## ADDENDUM NO. 1 TO ALL BIDDERS/OFFERS:

Reference – RFP 2022-083

Description: Hidden Valley Middle Cooling Tower Replacement

DESIGNED RWR	DRAWN RWR
CHECKED RDF	APPROVED RDF
COMM. NO. 21101.51	DATE 12-13-21
SHEET <b>M0</b>

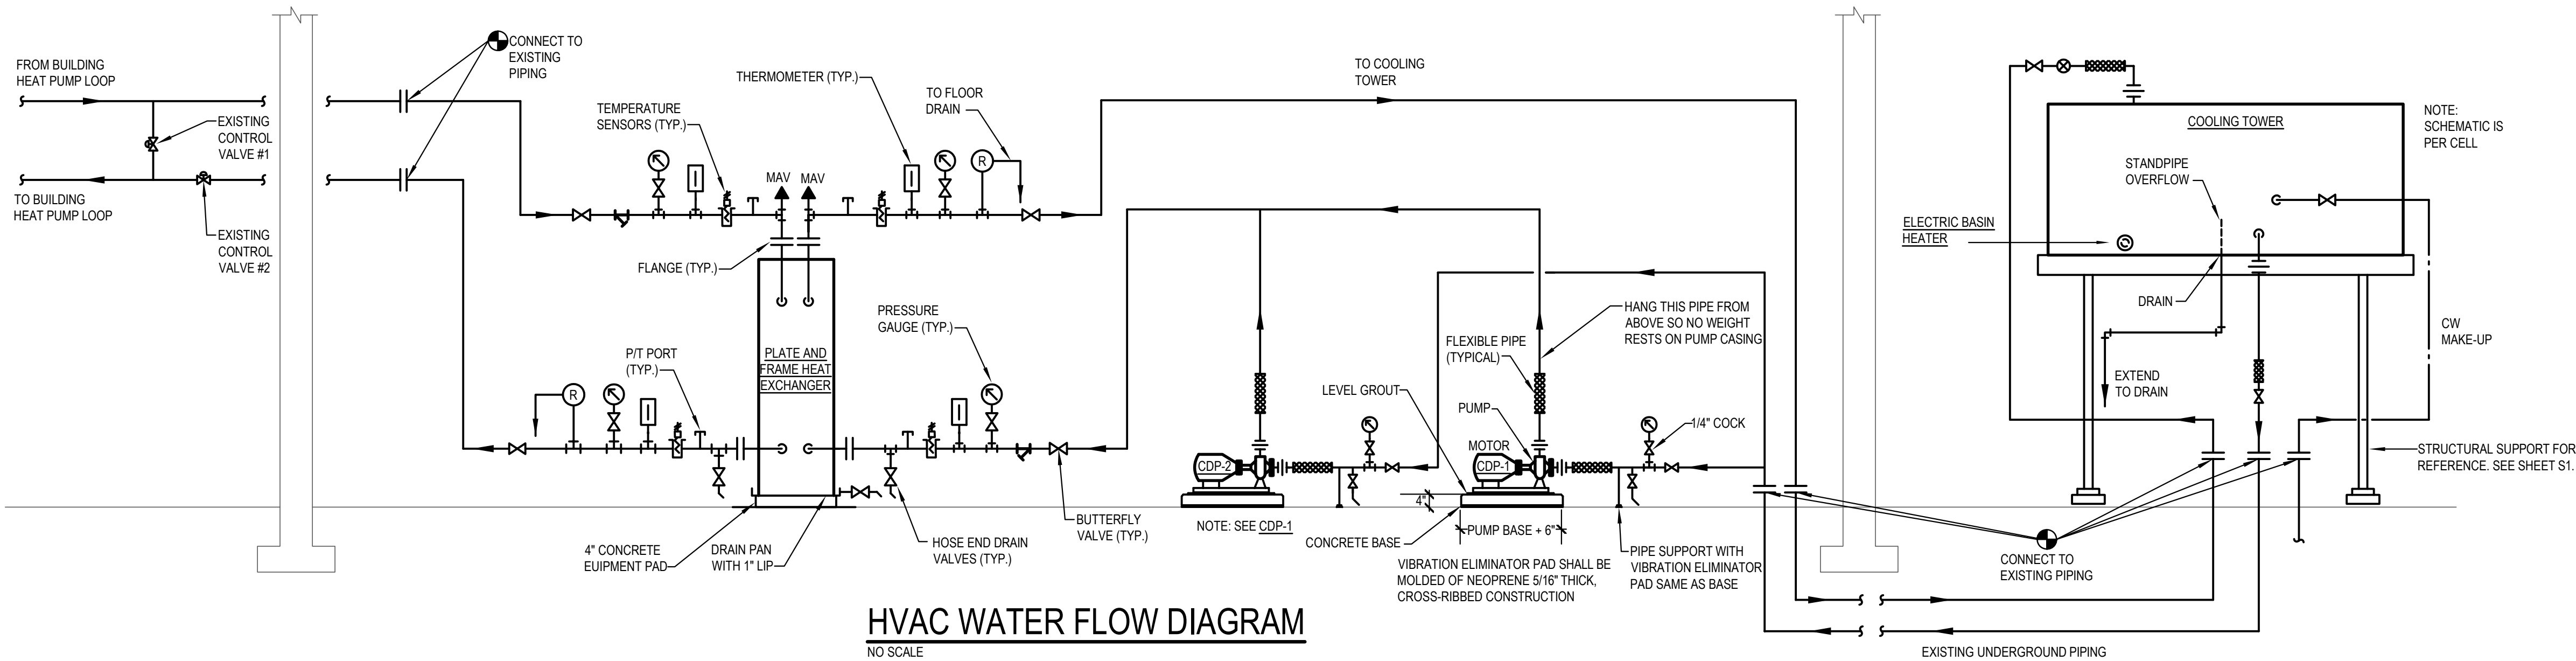
1. Clarification of Project Scope: Please see Exhibit 1 to this addendum for revised project plans. In the event of any conflict between this Exhibit 1 and the original project plans included in IFB 2022-083, this Exhibit 1 to Addendum 1 shall rule.
